UNITED STATES PATENT AND TRADEMARK OFFICE

10/511,119

Office Action Summary	Application No. 10/511,119	Applicant(s) CARDINE ET AL.	
	Examiner Jerry Redman	Art Unit 3634

5,855,095

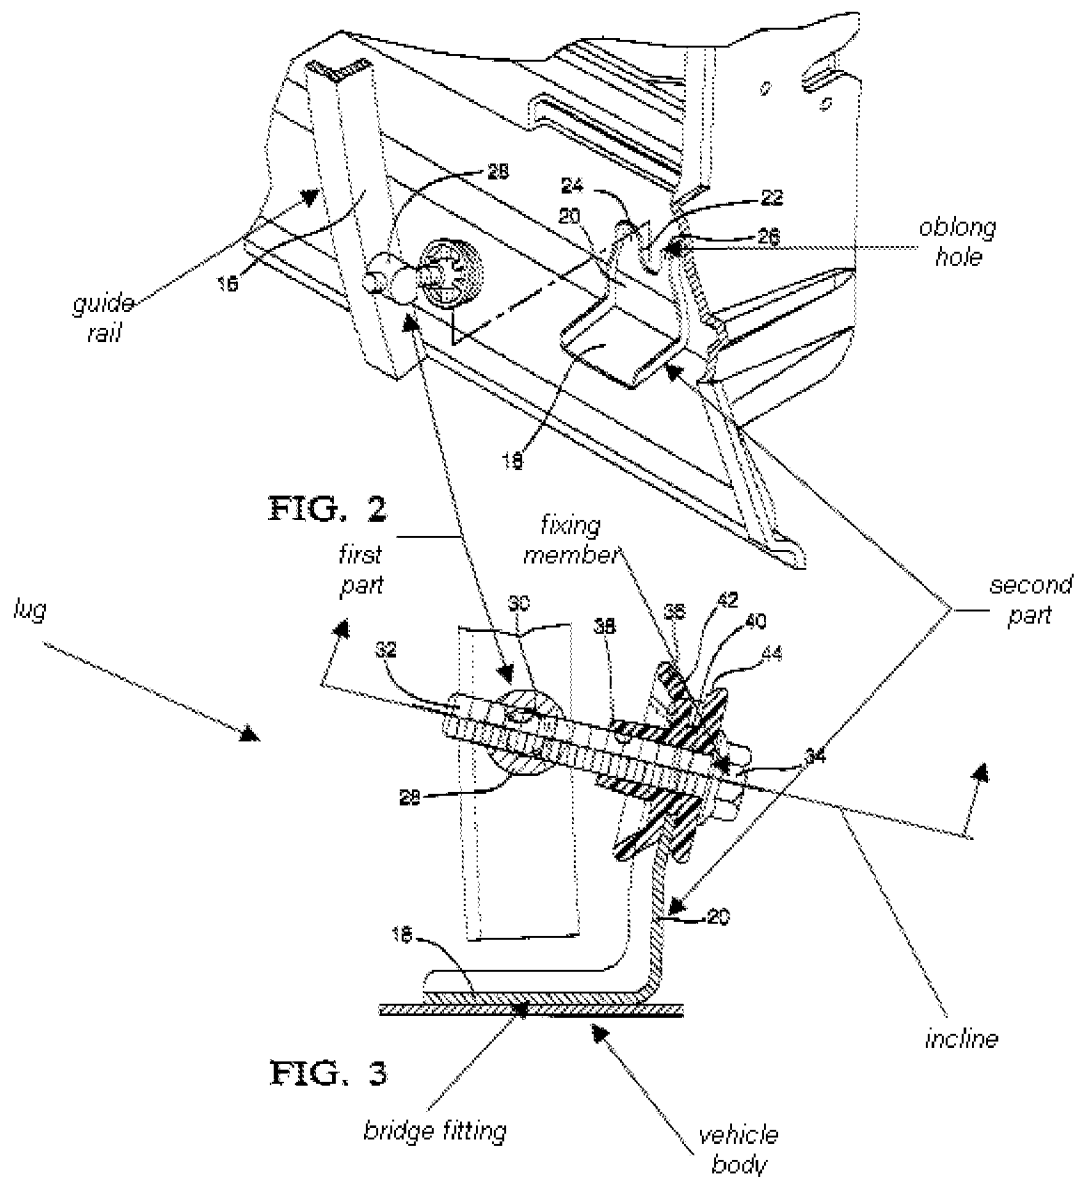
As best understood, claims 1-10 are rejected under 35 U.S.C. 102(b) as being anticipated by Dedrich et al., (5,855,095). As shown in detail below, Dedrich et al., (5,855,095) disclose having a first part connected to a guide rail which moves a window pane between an open and closed position, a second part fixed to the vehicle body (at 18) and having an oblong hole (22) for passage of a fixing member (34), and a bridge fitting (see figure below).
